Product Change Notification

Subject	<u>Notification of the change of Dust sensor variable resistors (VR) to lead-free materials</u>
Applicable Product Category	Dust Sensor GP2Y1010AU0F/GP2Y1013AU0F/GP2Y1014AU0F/GP2Y1014AUVF GP2Y1022AU0F/GP2Y1023AU0F/GP2Y1024AU0F/GP2Y1026AU0F
Changed From	Running change is scheduled for Jan 2025 onward.

Dust sensor: Regarding Change to lead-free materials

Changing in the material of the variable resistor (VR) installed in the Dust Sensor

構造略図 Structural rough sketch

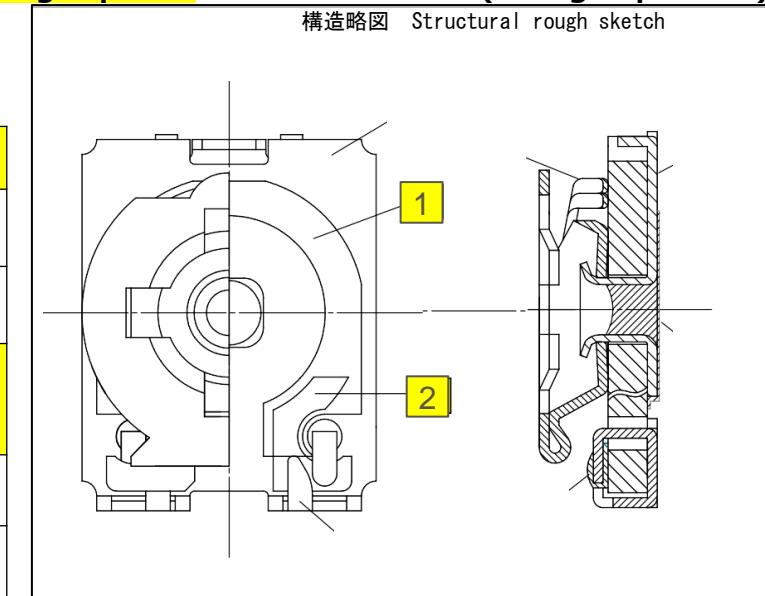
Changes points to lead-free of VR(changed product)

現行品 Current product	変更品 Changed product
メーカー名 Manufacturer	H社 (変更なし) Company H (no change)	
特長 Features	メタルグレーズ皮膜抵抗体 Metal Glaze type resistor element	抵抗体と電極材料に鉛化合物を含む Resistor and electrode material contains lead compounds
抵抗体と電極材料に鉛化合物を含む Resistor and electrode material contains lead compounds	抵抗体と電極材料に鉛化合物を含まない Resistor and electrode material does not contain lead compounds	
定格 Rating	同一 (仕様変更なし) Identical (no specification changes)	
機械的特性 Mechanical Characteristics	同一 (仕様変更なし) Identical (no specification changes)	
電気的特性 Electrical Characteristics	同一 (仕様変更なし) Identical (no specification changes)	
信頼性特性 Reliability Characteristics	同一 (仕様変更なし) Identical (no specification changes)

3) Sensitivity (Cigarette smoke detection)

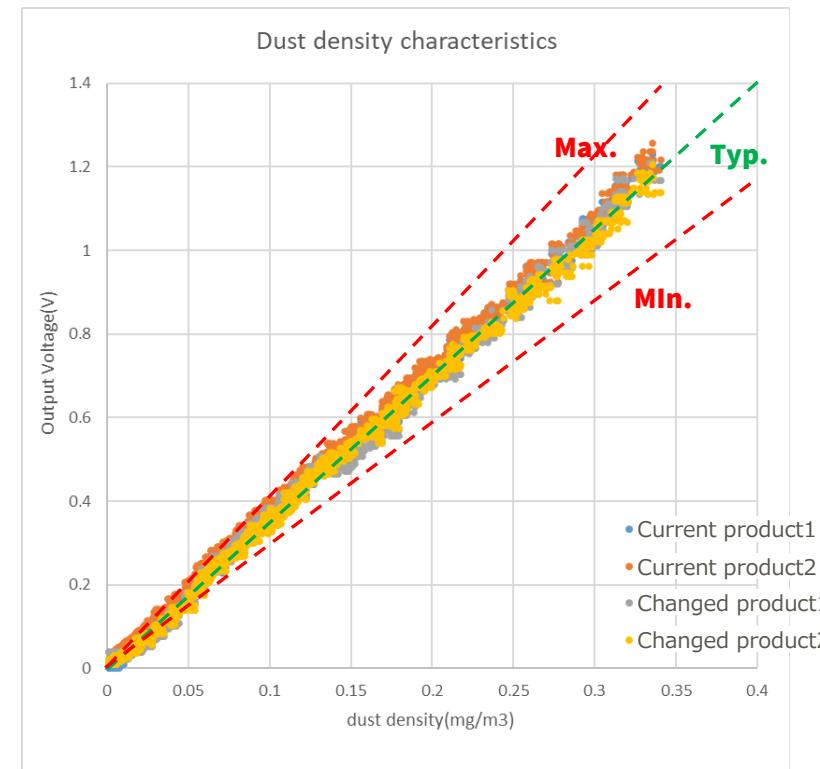
- This change in the VR's constituent materials has no effect on the characteristics described in the dust sensor specifications. The main characteristics of a representative model (GP2Y1026AU0F) before and after the change are shown below.
- We have also confirmed that there is no impact on the reliability items described in the specifications.

Spec.	Max.	0.41V/(100ug/m ³)
	Typ.	0.35V/(100ug/m ³)
	Min.	0.29V/(100ug/m ³)
